Machine	TASKI swingo 455-1855
Subassembly	Castor

Red optional wheels for castors

GTS Newsletter

2017/13E

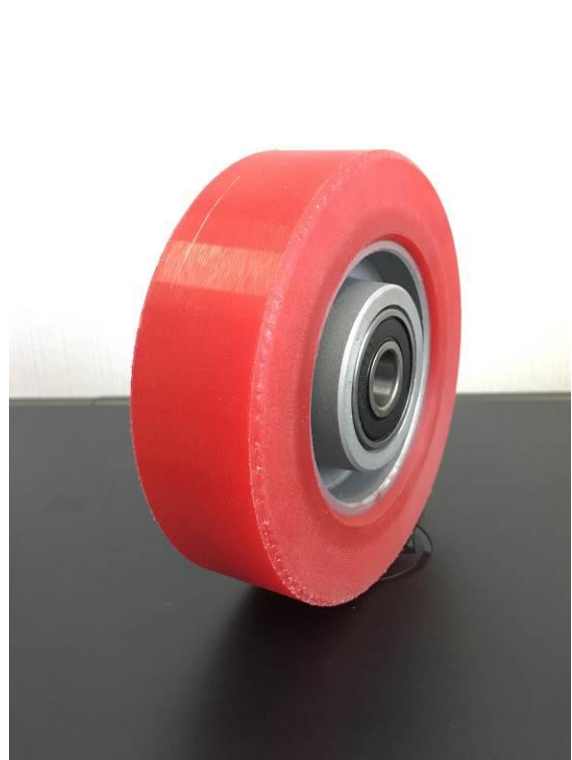
For quite some time there is a requirement for softer wheels for our castors. Depending on the kind of floor driven on, the current standard wheels can be too hard and therefore cause some sort of loud driving noise.

In order to act against this noise, a new rubber compound has been developed in collaboration with our supplier.

With immediate effect the new optional wheels are available for both castors:

- 4127101 (TASKI swingo 455-955)
- 4122600 (TASKI swingo 1255-1855)

Please note that the wheels are delivered as single parts without any extras, such as thread guards or mounting materials. These have to be taken over from the existing castors.
